## **Historical Architectural Review Board COA Preliminary Review Sheet**

HDC-2025-00003

Address: 213 N. Fountain Street

Proposal: Installation of new garage door, windows, and doors.

**Elevation at Russell Street (Applicant)**

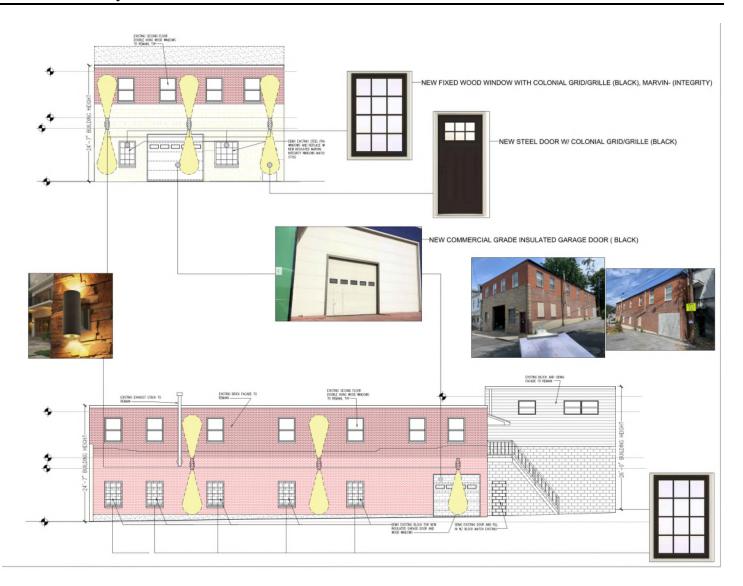
The removal of the CMU block infill at the original windows and garage door locations along Russell Street is appropriate and commendable and helps restore some of the character of the original building.

It would be appropriate for the existing first floor windows on Fountain Street to be repaired instead of replaced, or sufficient evidence should be shared showing that the windows cannot be repaired. While the proposed windows include a muntin pattern consistent with the existing original windows on the first floor, they do not match in materiality and frame dimension. The replacement first floor windows along Russell Street should be steel windows matching the existing first floor windows on Fountain Street in size, type, operation, profile, and appearance.

The style of the proposed garage door is not consistent with the historic district. For the primary garage entry on Fountain Street, a more historically-consistent configuration would be appropriate. There are historic examples of 1930s garage doors that have upper lites, similar to the configuration of the proposed steel entry door. That style garage door paired with the proposed entry door would be a complementary pairing for the front elevation. Other examples of garage doors from that era consist of solid sectional doors with square inset panels, as seen nearby at 926 Oak Street. It would be appropriate for the garage door on Russell Street to be consistent these styles, but given its location on the secondary façade, it would also be appropriate to install a solid sectional door.

- The existing first floor windows on Fountain Street remain and are repaired as required, or evidence submitted that the windows are beyond repair.
- The replacement first floor windows along Russell Street match the existing first floor windows on Fountain Street in material, size, type, operation, profile, and appearance. Replacement window product information is to be approved by staff, and finish color for existing and replacement windows is to be decided by applicant.
- The garage door on Fountain Street is an architectural sectional garage door in a design consistent with the historic period. The garage door on Russell Street may match the one on Fountain Street or be a solid sectional door. Garage door product information to be approved by staff.
- The building lighting is installed as submitted.
